8A Miscellaneous Electrical Systems

The information in this appendix of the reference ABWR DCD, including all Subsections and figures, is incorporated by reference with the following departures and supplements.

STP DEP 1.1-2 (Figure 8A-1)

Figure 8A-1 Site Plan (Grounding)

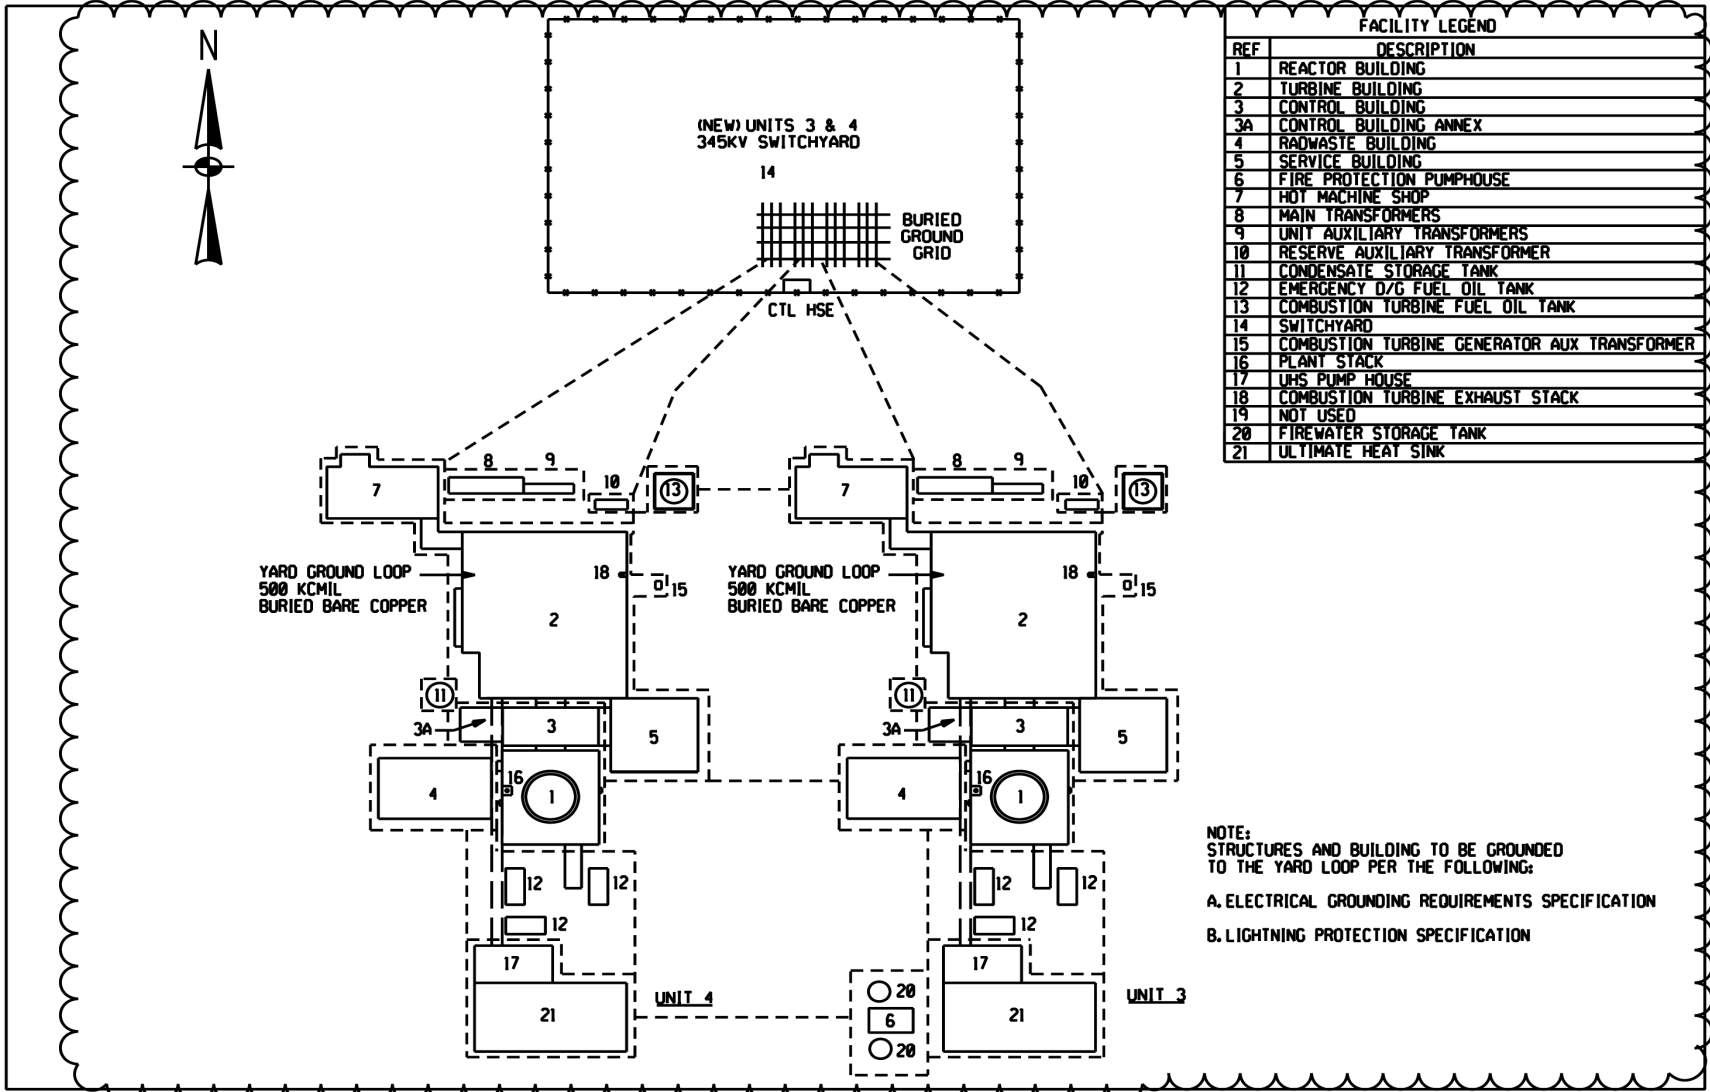
STP DEP 1.1-2

- (3) A plant grounding grid shared between STP Units 3 & 4
